DESIGN REVIEW: RECOMMENDATION

1422 SENECA STREET, SEATTLE, WA 98101

PROJECT #:3034493-EG

ENLARGED SITE PLAN OF BUS STOP

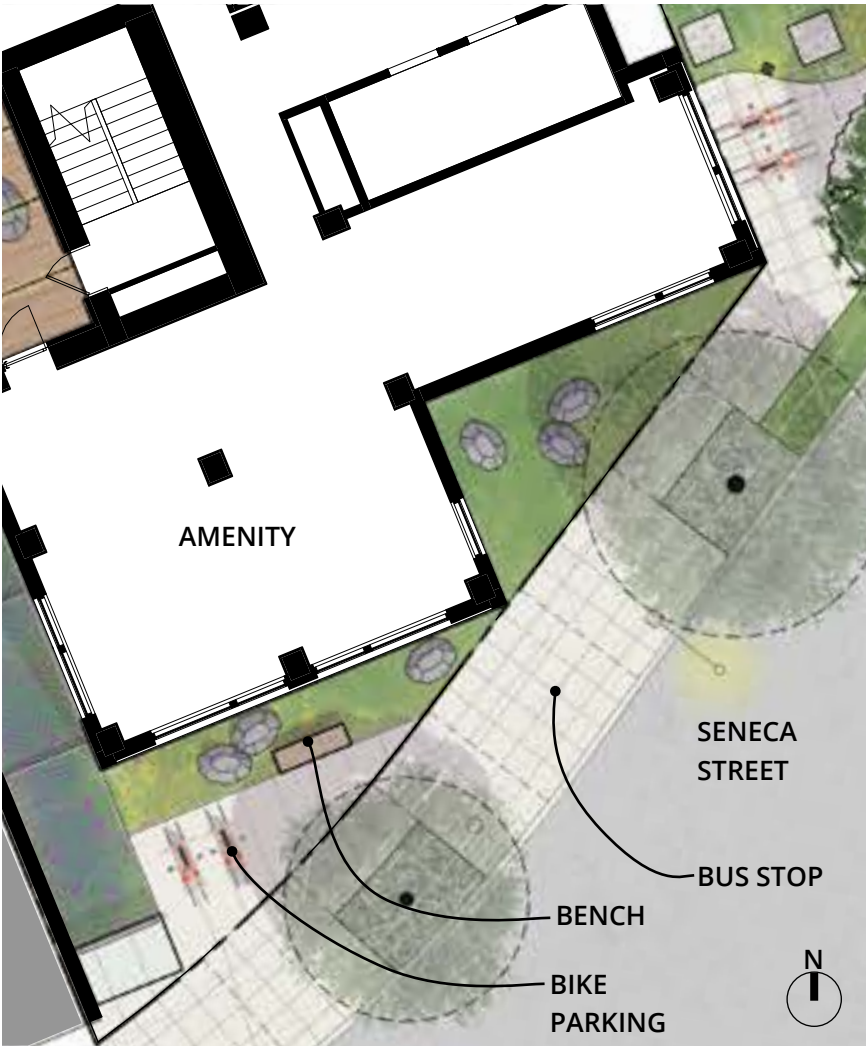
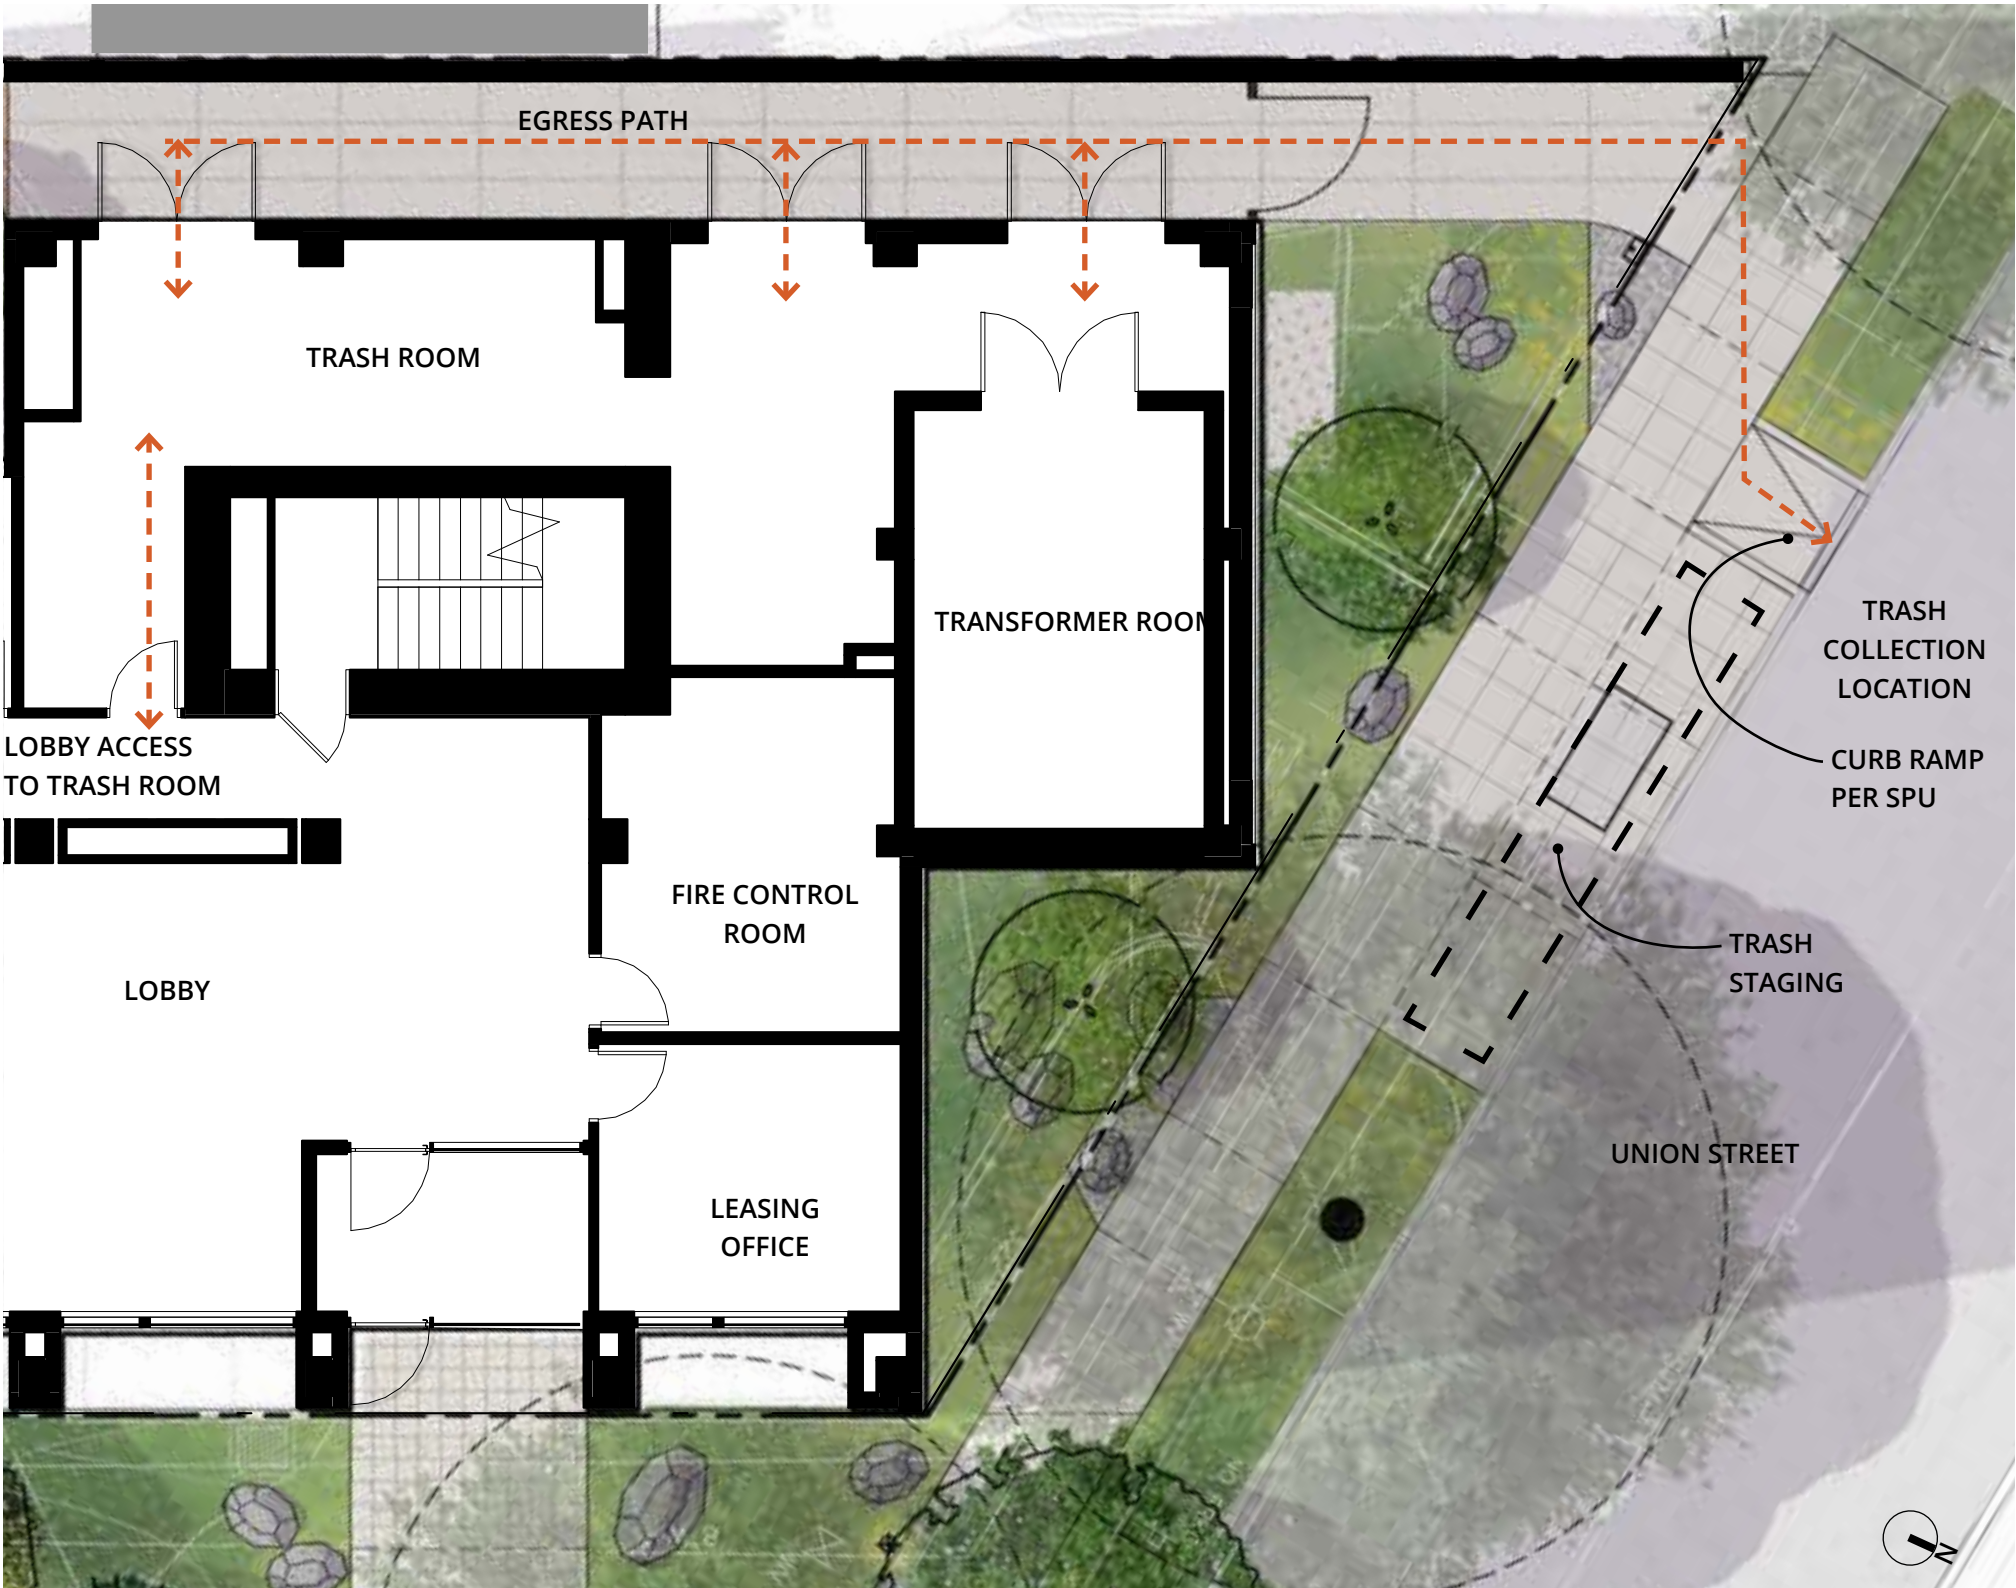
The Board supported the provision of additional space for the bus stop on Seneca St.

The Building massing is setback at the bus stop to provide relief at the bus stop. The landscape plan has been developed to include benches and additional paving as a benefit to public transit riders along Seneca Street.
